J. Zanesville Energy, LLC, Case No. 14-2254-EL-REN

Summary: Reply electronically filed by Mr. Bruce Bailey on behalf of Zanesville Energy, LLC

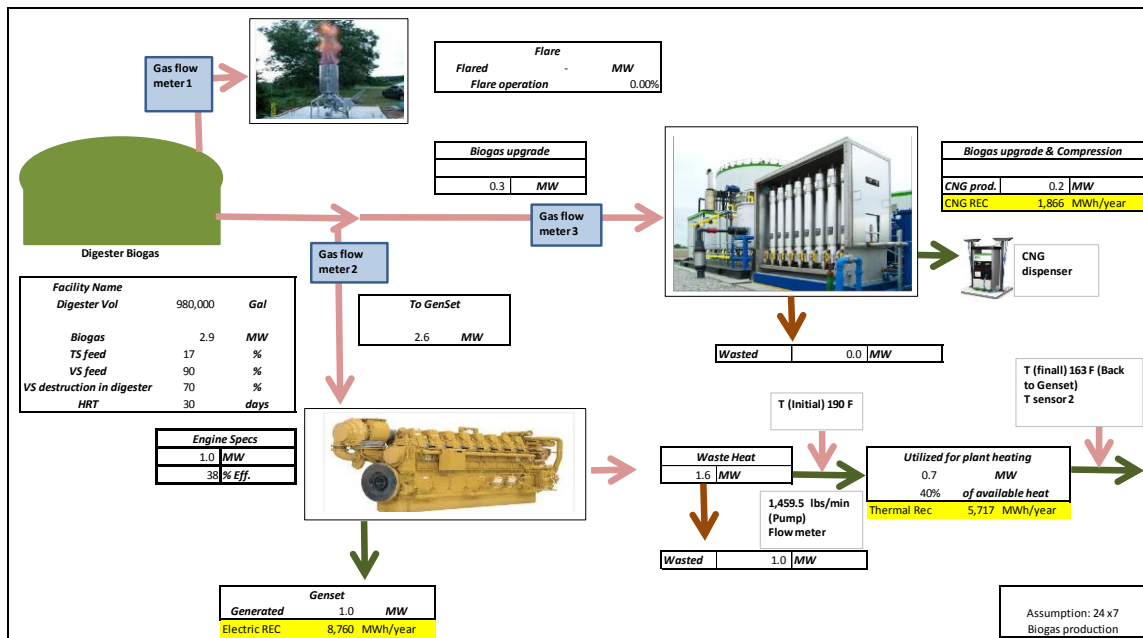
12. Regarding Section G.3 of the application, please provide a detailed description of how heat captured by each source is going to be measured and verified, including the configuration of the meter(s), the meter types(s), and meter accuracy. What is the projected in-service date of the thermal meters? Please provide documentation.
Thermal REC: Engine is cooled using a heat loop which circulates Glycol-Water mixture (50%) across the plant. The flow of the glycol is **175 GPM** (Pump rating, see fig.).

We have temperature sensor located in the engine which show the temperature of glycol taking waste heat from the engine. **The temperature is typically around 190° F** (See fig. 1) This glycol flows in the plant supplying heat for plant purpose (Digester heating, Floor heating, Pasteurization). **The return temperature of glycol is around 163° F** (See fig. 1)

$$\text{Heat utilized in the plant } \frac{\text{BTU}}{\text{min}} = 1,460 \frac{\text{lbs}}{\text{min}} * (190 \text{ F} - 163 \text{ F})$$

$$\text{Heat utilized in the plant } \frac{\text{BTU}}{\text{min}} = 39,808 \text{ BTU/min}$$

$$\text{Heat utilized in the plant } \frac{\text{BTU}}{\text{hr}} = 39,808 \frac{\text{BTU}}{\text{min}} * 60 \frac{\text{min}}{\text{hr}}$$

$$\text{Heat utilized in the plant } \frac{BTU}{hr} = 2,388,499 \frac{BTU}{hr}$$
